LOCAL HISTORIC DISTRICT: Wilmore

PROPERTY ADDRESS: 1822 Wickford Place, Lot 2

SUMMARY OF REQUEST: New Construction

HDC-2019-00364

402 ROOF PLAN
A4.1

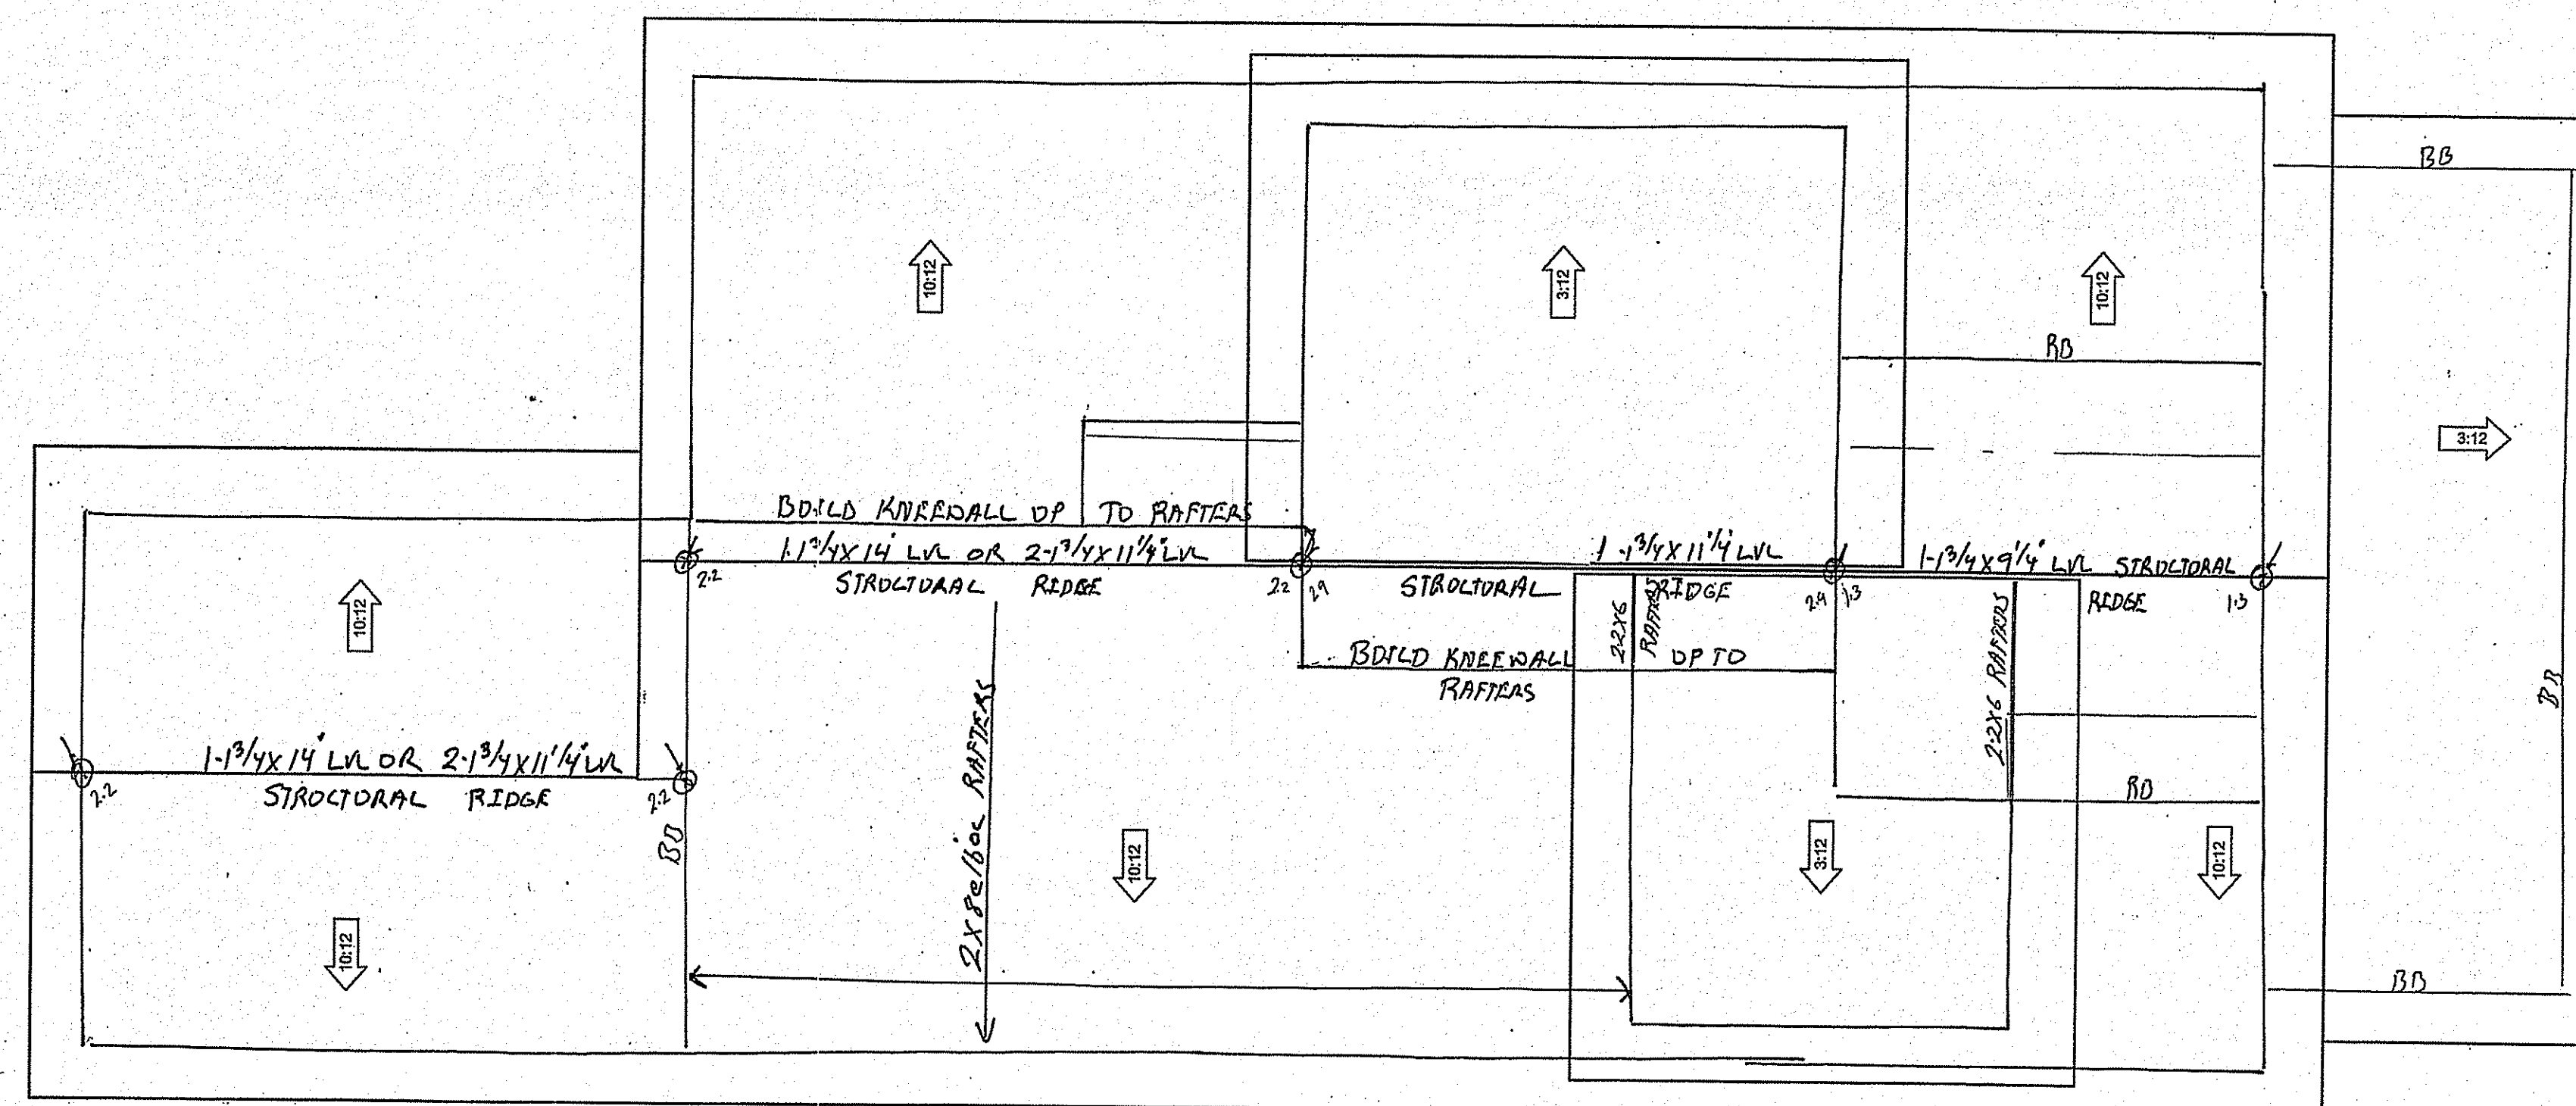
3. Roof overhang not changed per condition.
4. V-groove bead board soffit not noted on plans.
5. Staff concern over Elevation Notes on A3.1 that German-style siding, door, and window styles to be selected by owner.
6. The project is not incongruous with the district and meets guidelines for New Construction.
7. Staff Recommends reinstating the **Approval with Conditions with Staff to work with applicant**, per 10.4.1 of the Rules for Procedure.
8. If requested by a Commission member, or if an interested party has signed up to speak in opposition, then the HDC shall open the application for a full hearing.

PROVIDE 16" OVERHANG THROUGHTOUT U.N.O.

SITE PLAN – (UPDATED)

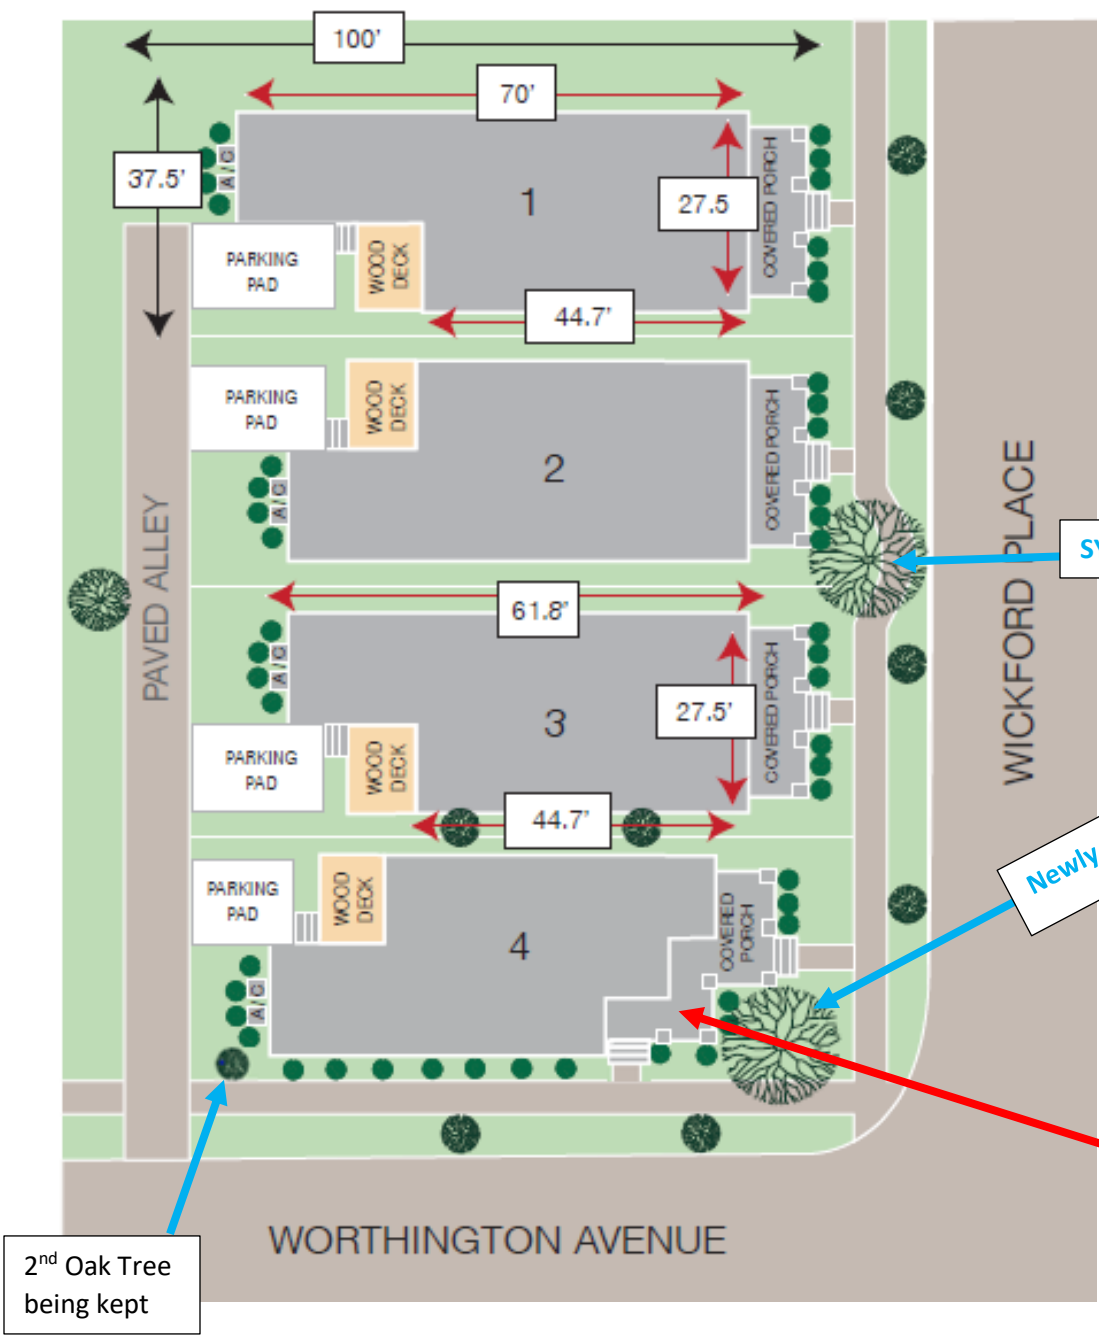
- LOT 1 - stays the same but we have taken the roofline down 1 ft.
- LOT 2 - stays the same but we have taken the roofline down 1 ft.
- LOT 3 – the front dormer has a gable above it, and the roofline came down 1 ft.
- LOT 4 – the front porch wraps-around along Worthington and is positioned for us to save the Oak Tree

TREE SAVE - (UPDATED)

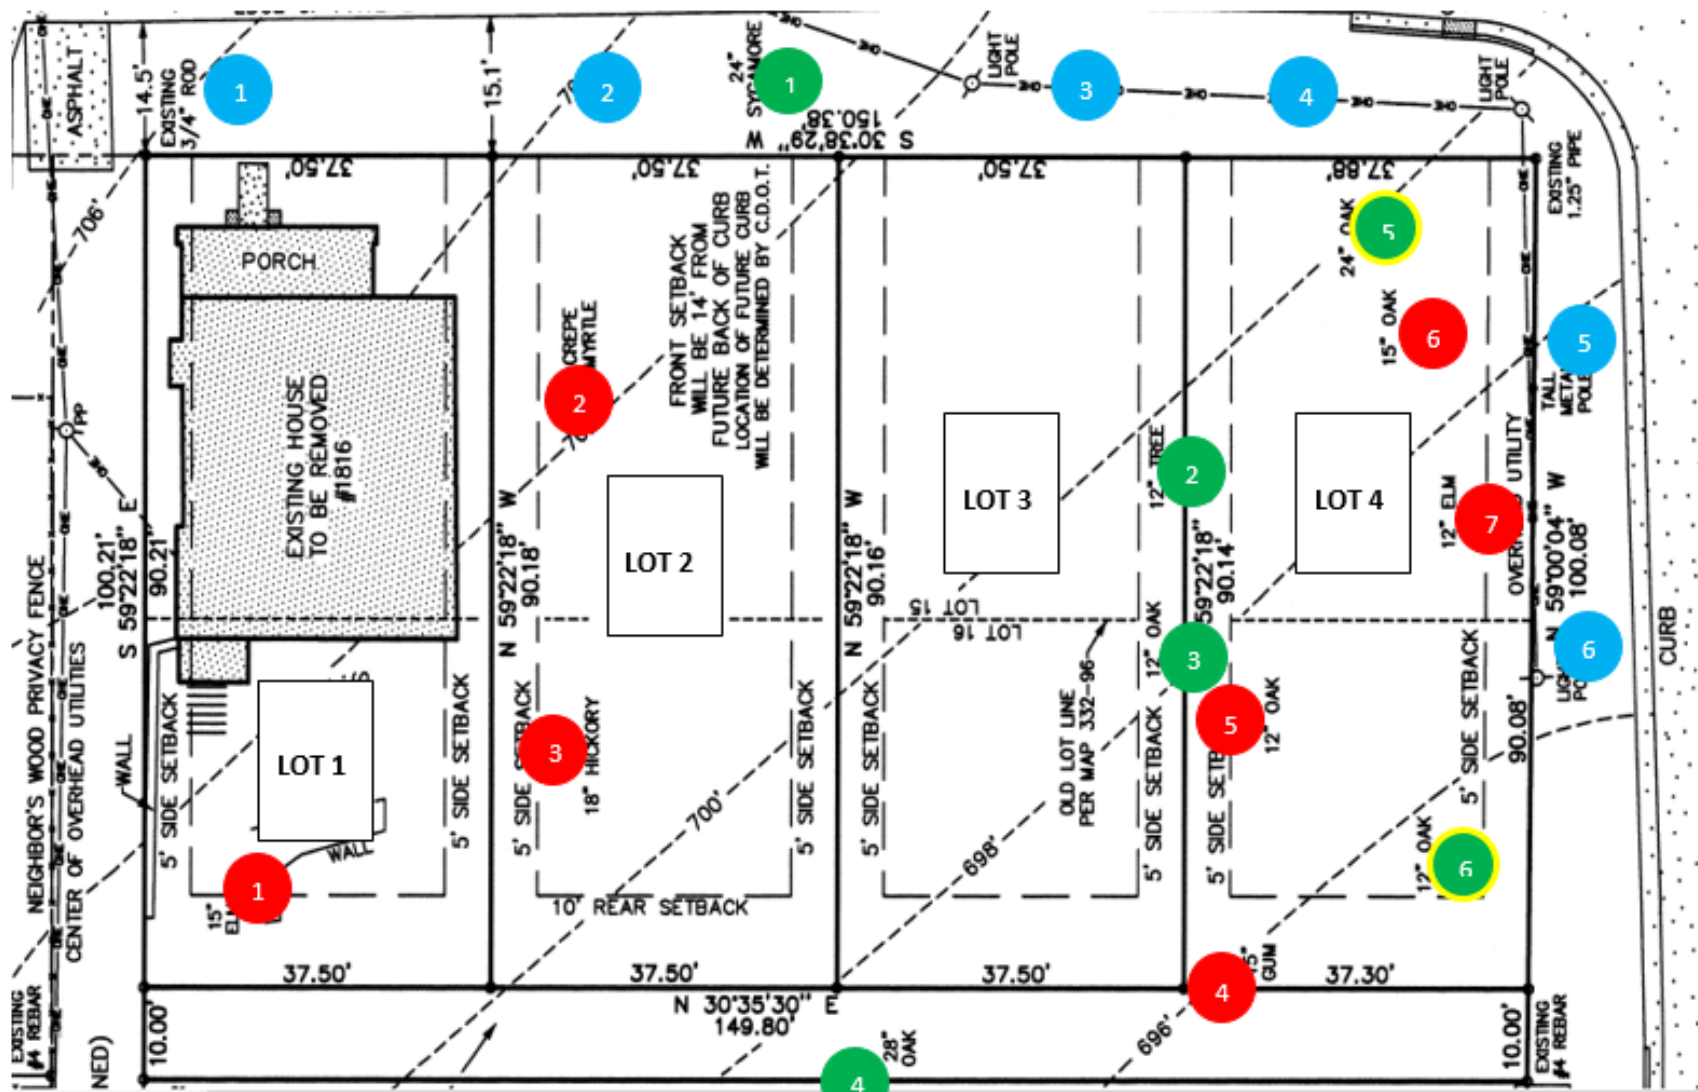
LOT 4 – created a wrap-around porch that runs along Worthington Ave for more curb appeal at the Worthington & Wickford corner. Added stairs on the Worthington Ave. side as well. Pushed the house slightly back to be able to keep the Oak Tree.

LOT 2 – (UPDATED)

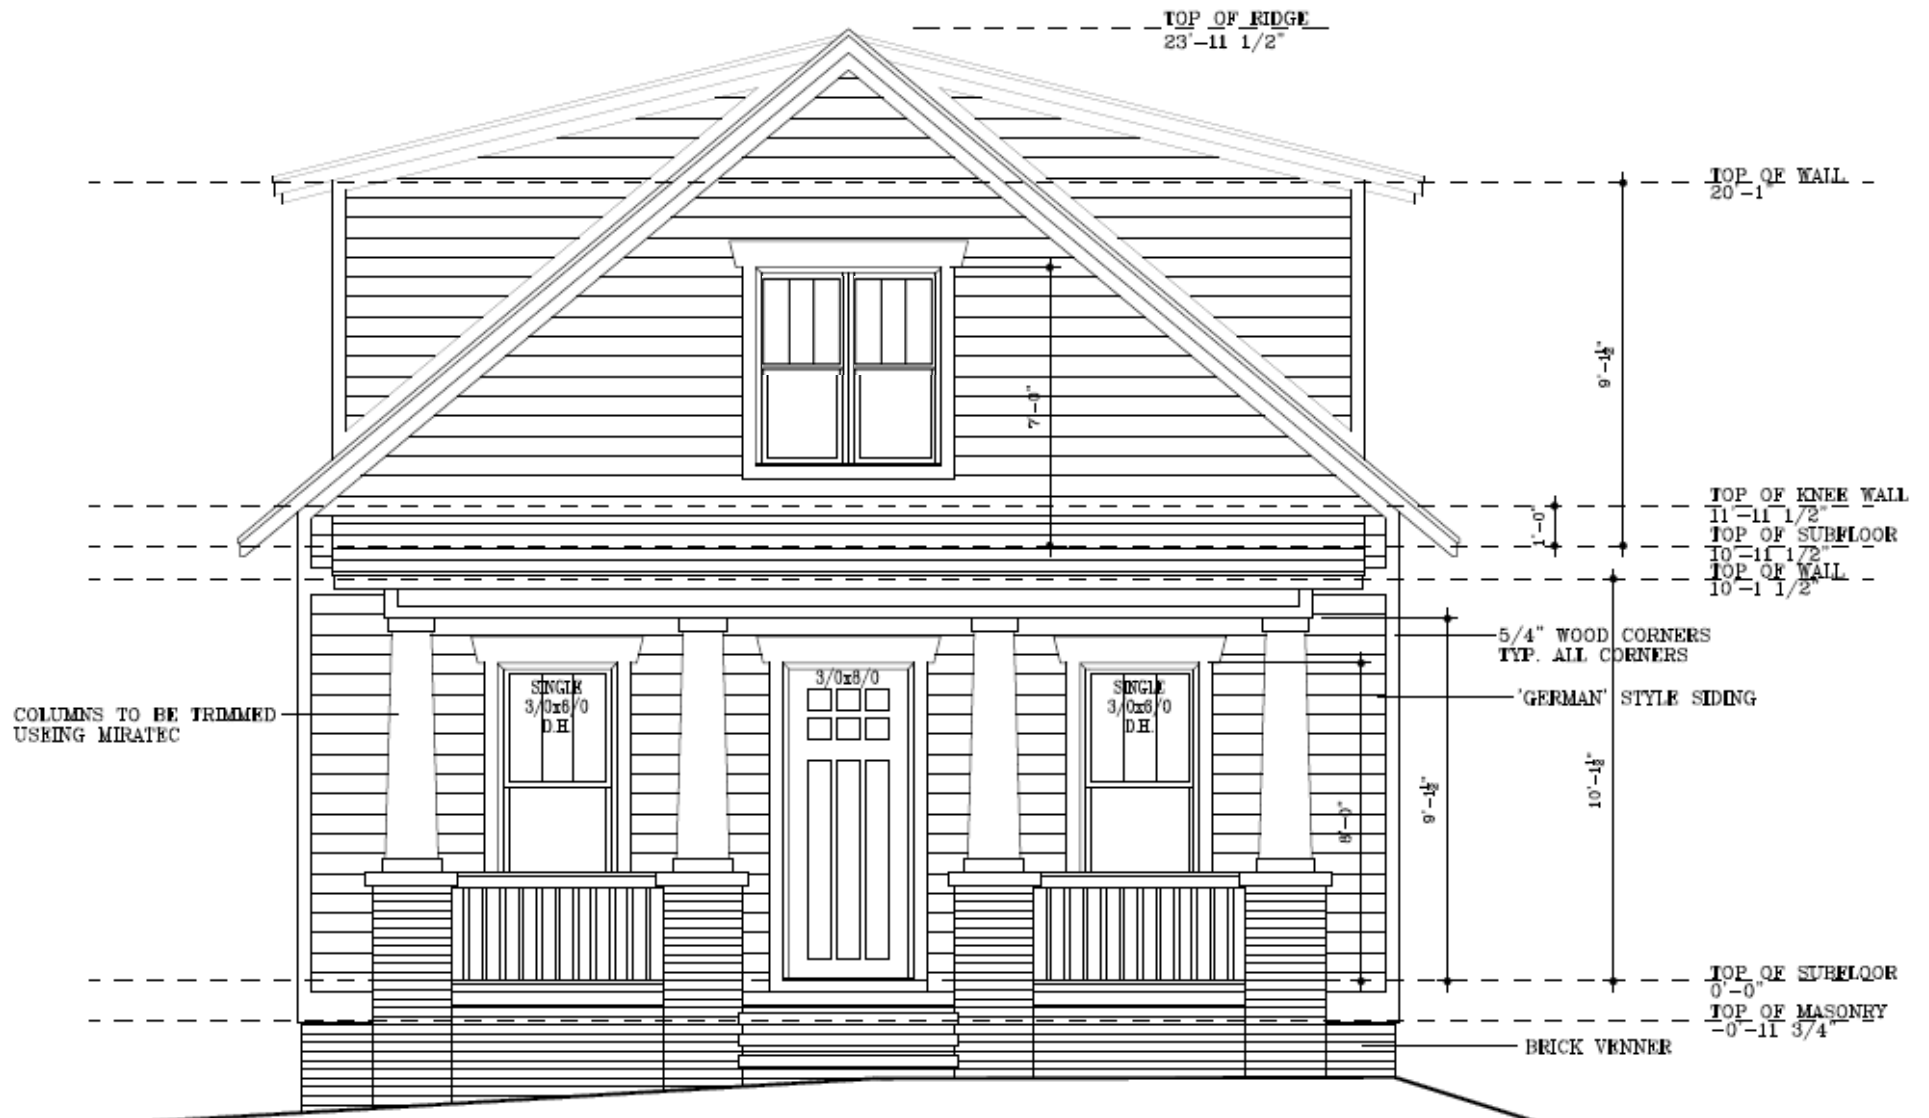
LOT 2 - HEIGHT / MASSING

- We have reduced the roofline by 1 foot to 23' 11.5", by making the 2nd Floor 9' ceiling height.

WINDOW DETAIL – **UPDATED**

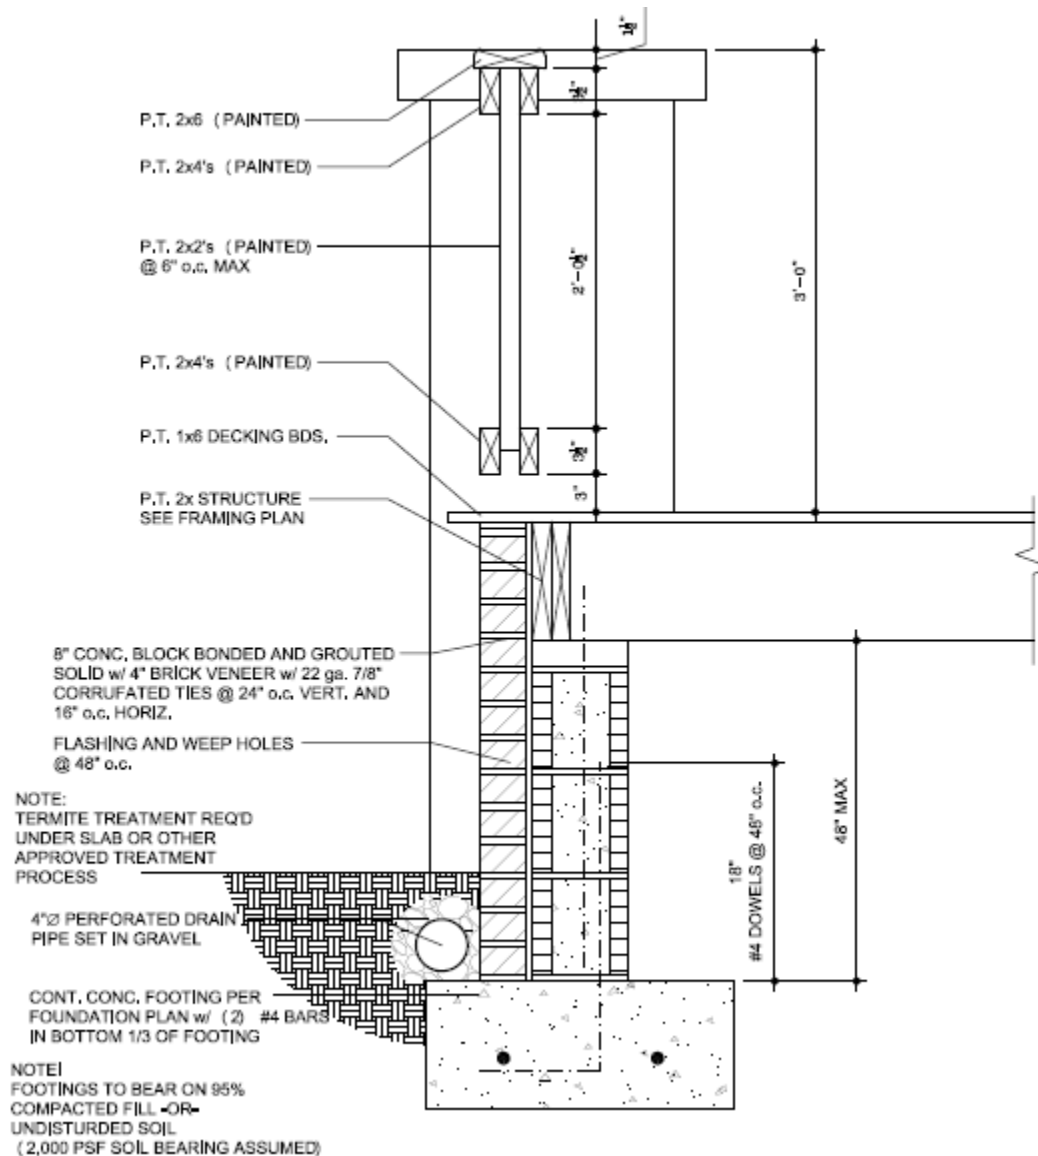
- *Miratek installed on columns, corners, fascia*
- *Windows– Take brick casing off, 4" wide non- tapered trim with 7/8 inch putty glaze*
- *Roof overhang extended to 24 inches at right angle to siding*
- *¾ individual V-groove bead board soffit*
- *2X8" barge rafters with bed mold installed base*
